Product Change Notification - SYST-11STMR599

ERRATA - IS2062/IS2064/BM62/BM64 Data Sheet Errata

IS2062/IS2064/BM62/BM64 Data Sheet Errata

Figure 1-2. IS2062/IS2064/BM62/BM64 with Capacitor

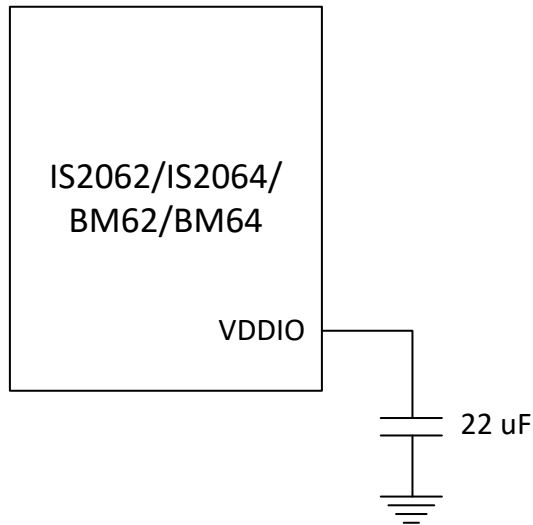
If power goes down during the EEPROM write operation before it is completed, then a page of data in EEPROM may be corrupted. The first operation in an EEPROM write is a page-erase operation and typical evidence of EEPROM corruption is a 64-byte sequence of 0xFF.

TWC (Total Write Time Cycle) for the EEPROM to complete an EEPROM write operation is 5 ms. A sudden power drop during the EEPROM write operation can result in corruption of EEPROM data in the page where the data byte resides since the writing of the data has not completed after the page erase process due to insufficient time allowed (5 ms). The page erase action will cause 64 bytes to become 0xFF before the data writing inside the page has concluded.

Add a capacitor on the VDDIO power pin to delay the power drop to the EEPROM voltage supply line so that the TWC requirement may be met.

Both IS2062/IS2064 and BM62/BM64 data sheets specify an external Reset IC to protect the system from power drop. In addition to this protection IC, a 22 uF to 100 uF capacitor is suggested to add on the VDD_IO pin for delaying the power drop timing.

Figure 1-3. RST_N Signal and VDDIO Drop Timing Sequence

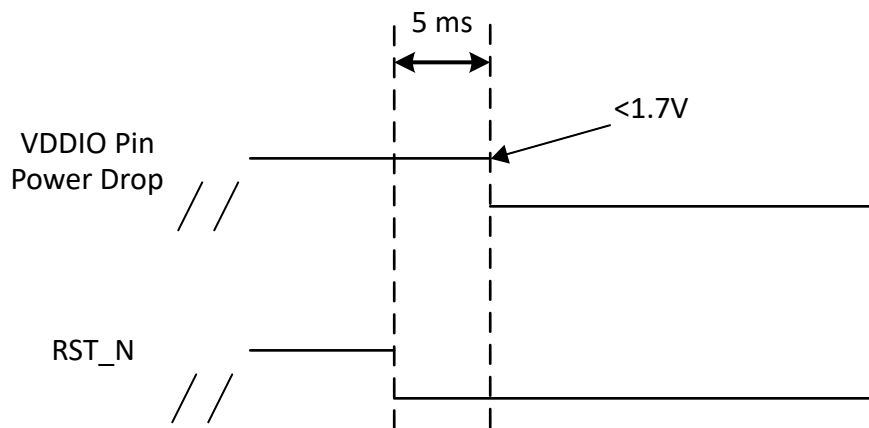
1) Updated Figure 1-3

Revision	Date	Section	Description
B	01/2020	Figure 1-3	Updated figure
A	11/2019	Document	Initial Release

Timing sequence for the RST_N signal and VDDIO drop is shown in the following figure.
